Common Council

Agenda

SUBJECT: Recommendation of Plan Commission Regarding a Precise Implementation Plan (PIP) for proposed Notre Dame School at 100 S Huron Street (Parcel ED-1013).

ITEM X: Staff recommendation and possible action regarding a Precise Implementation Plan (PIP) for proposed Notre Dame School at 100 S Huron Street (Parcel ED-1013). Submitted by Groth Design Group. *

Proposed PIP Site Plan

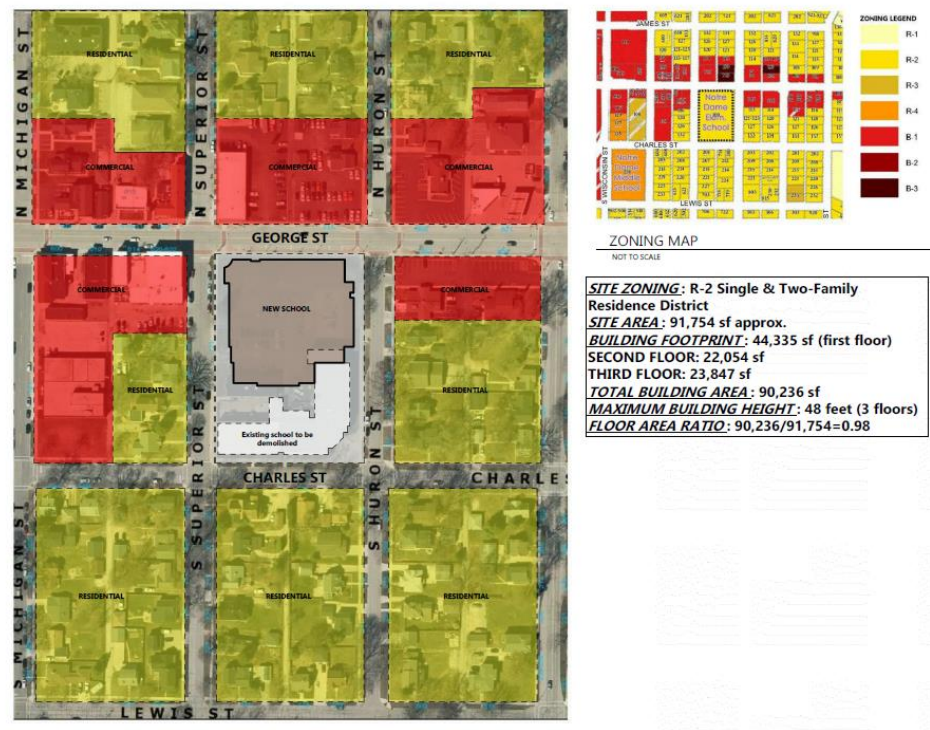
There has not been enough time to update the site plan to reflect the Council approved conditions so they have been included in the staff comment/condition section of this report and are referenced in the recommendation.

The site plan shows the Superior Street public sidewalk on private property in order to accommodate the car drop off area. Per the Council approved conditions of the rezoning and general plan, we will work with the applicant to realign the street in order to accommodate one-way traffic and also maintain the public sidewalk in the right of way.

SITE DETAIL SHEET

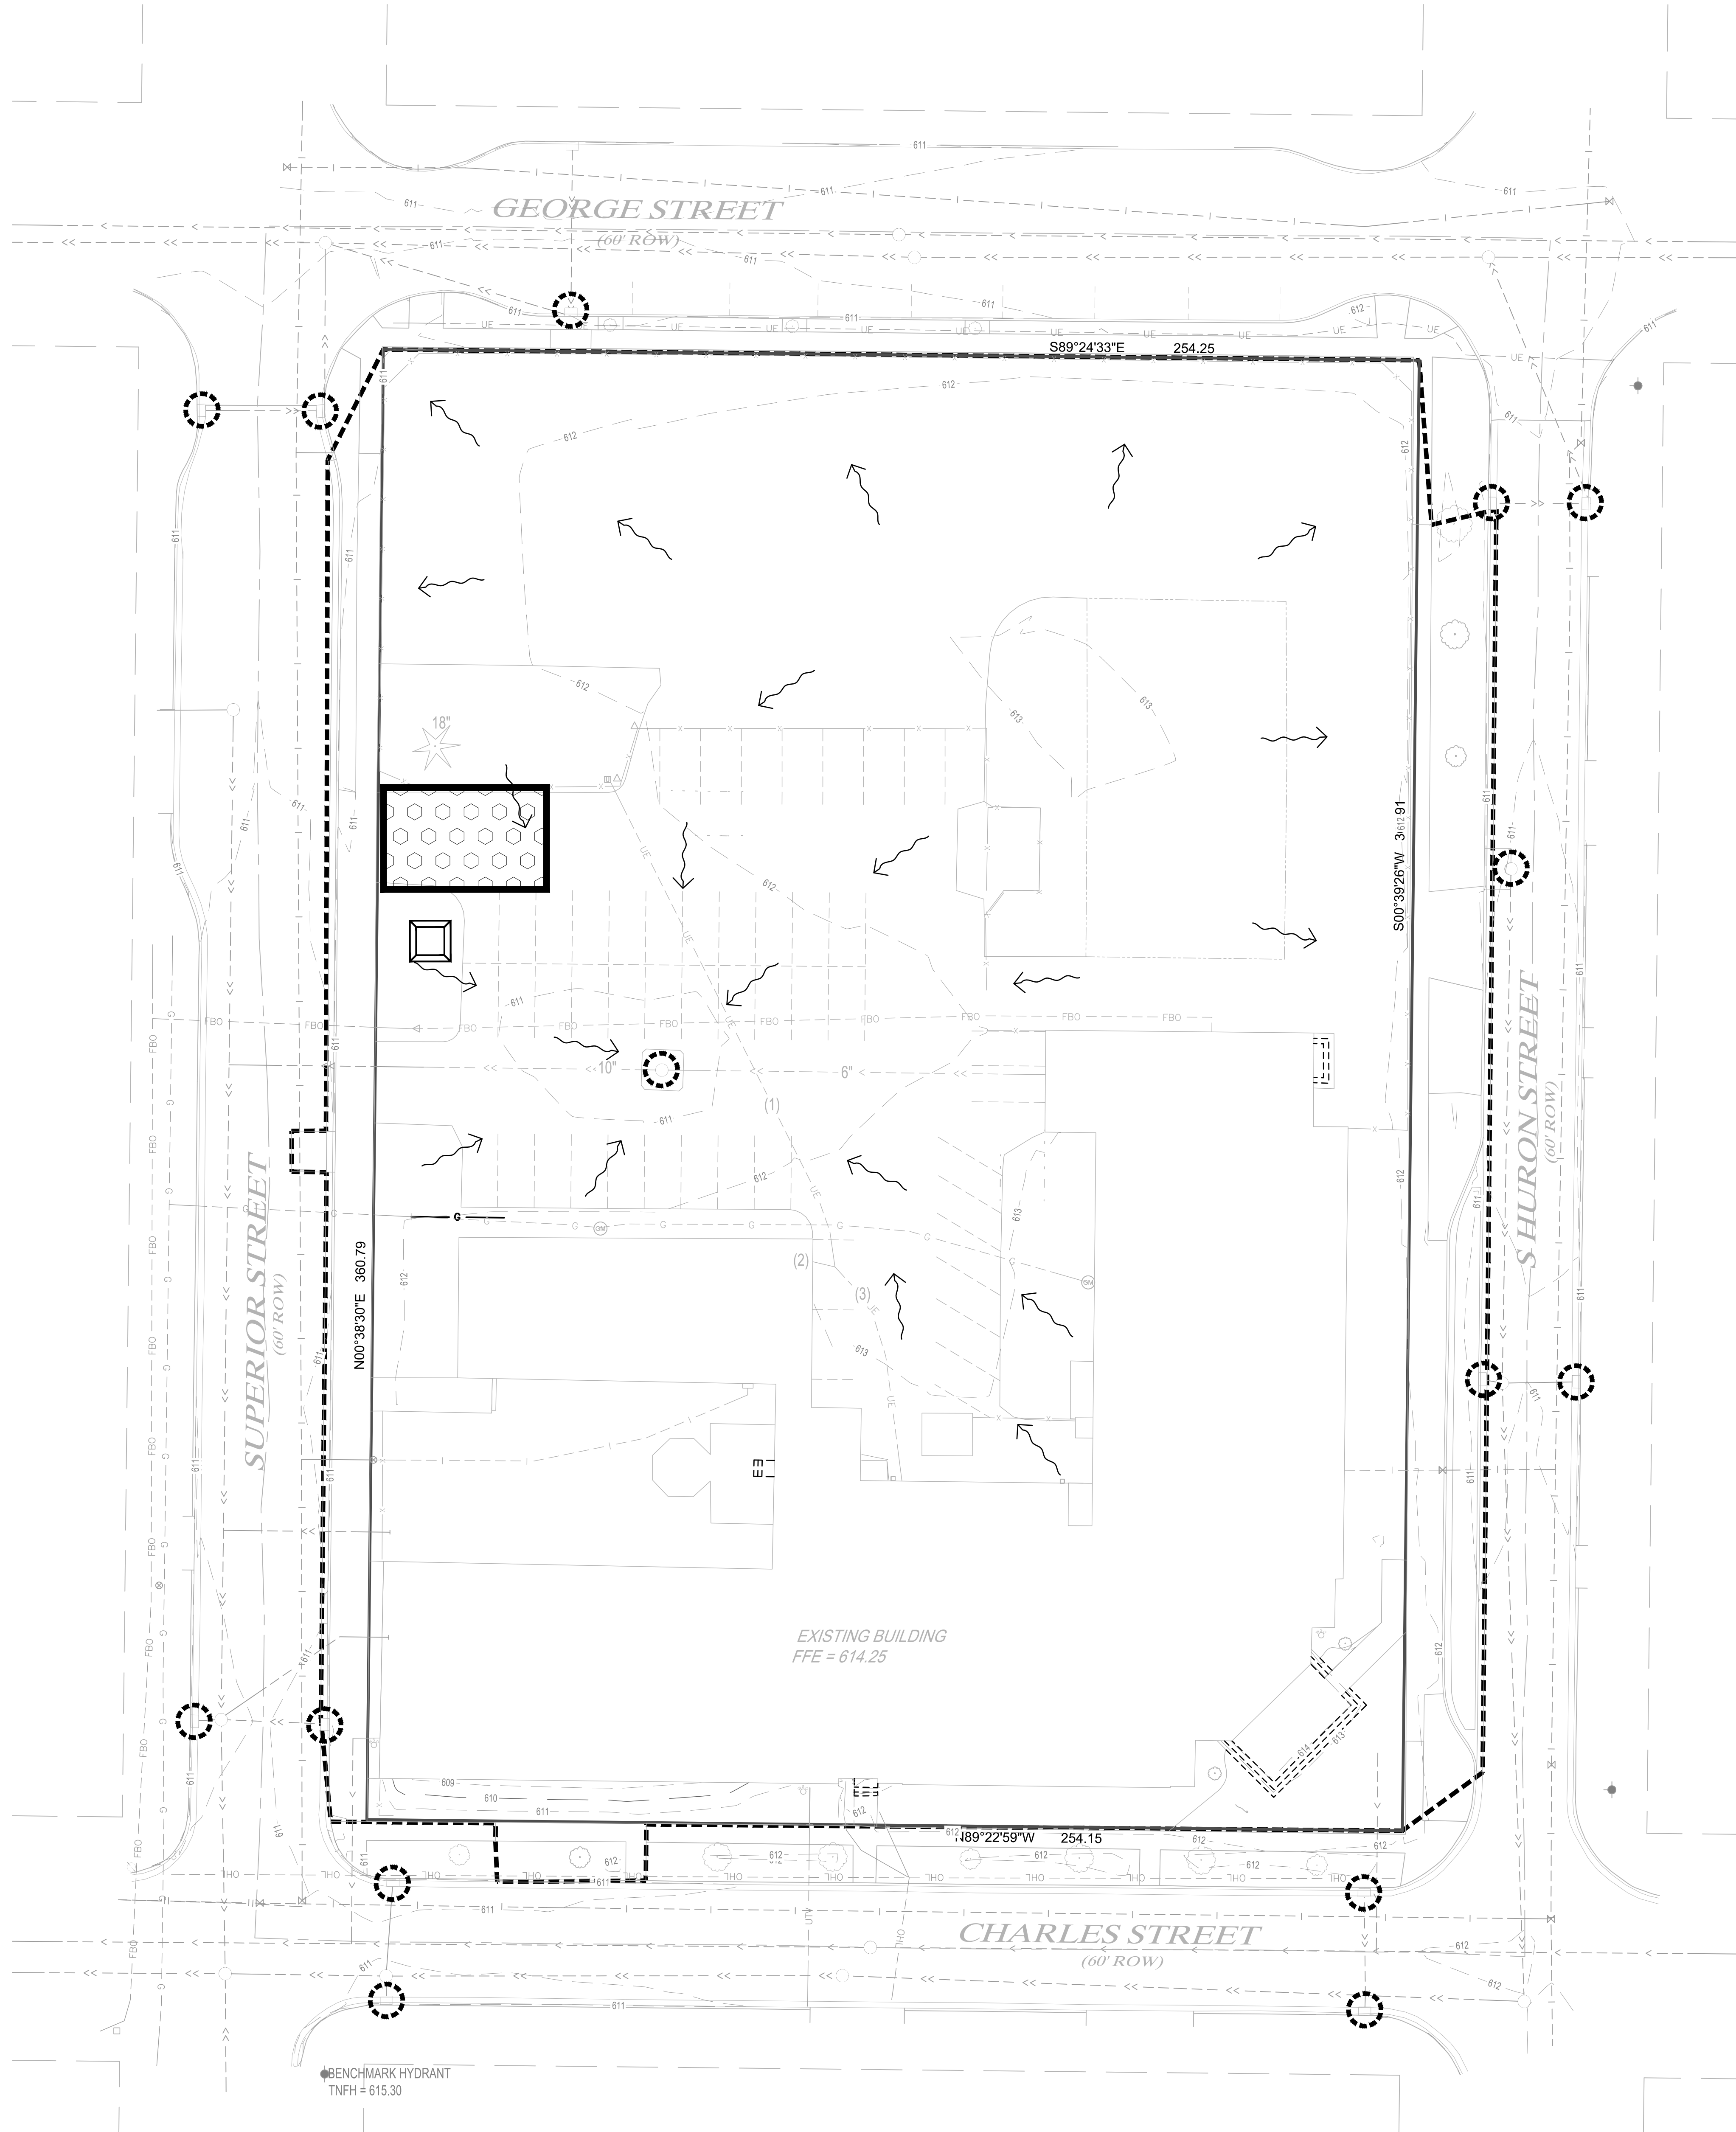
15. Please provide all information listed Site Plan Checklist.
16. Sheet C0-20: Sidewalk concrete pavement detail - the City only requires 4" concrete sidewalk in right-of-way. 8-inch concrete sidewalk is required at driveways. Concrete workers license provides specifications for reinforcements.

17. Sheet C0-22: Driveway sections require 8-inch concrete sidewalk.
18. Sheet C3-10: Comment 9 - curbing in the ROW will need to be 24-inch. Also need to show restoration of sanitary sewer lateral and water lateral abandonment and any other utility abandonment in the ROW.

C1-31

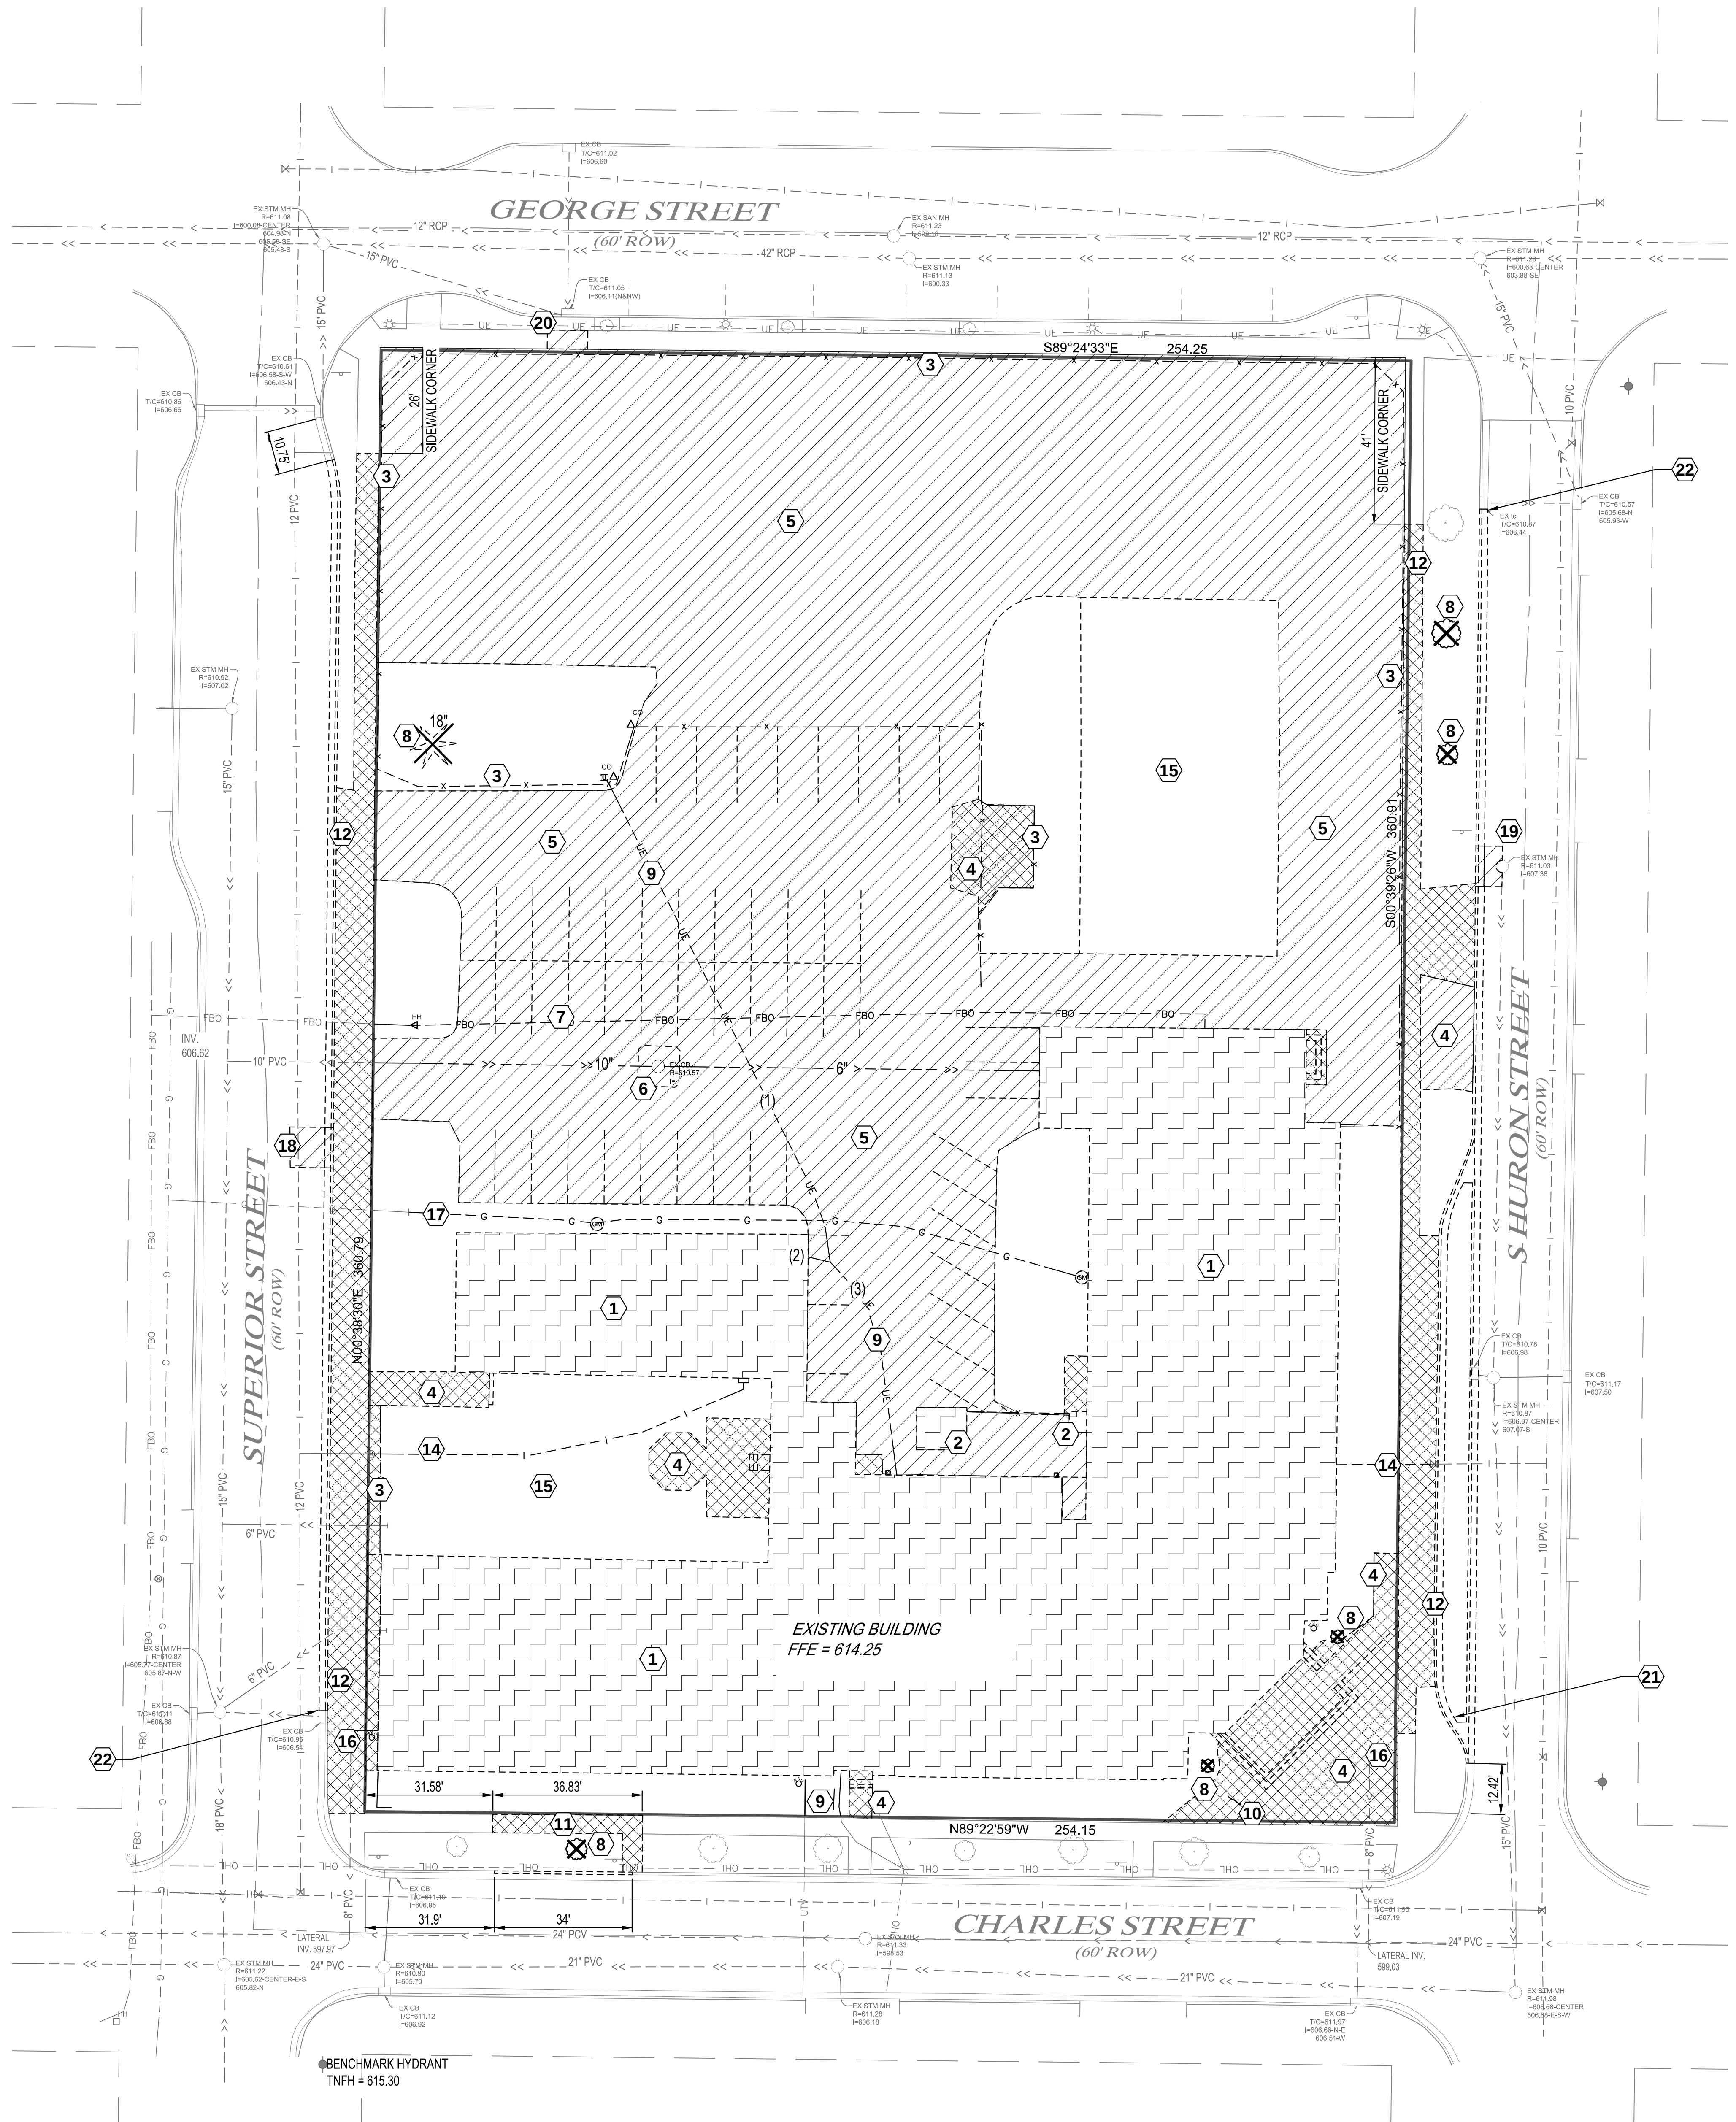
2. Stockpile locations will need to be called out and erosion control provided at these locations. Inlet protection Type D is required at all inlets. Call out inlet protection type D on plans. (Sheet C1-10).
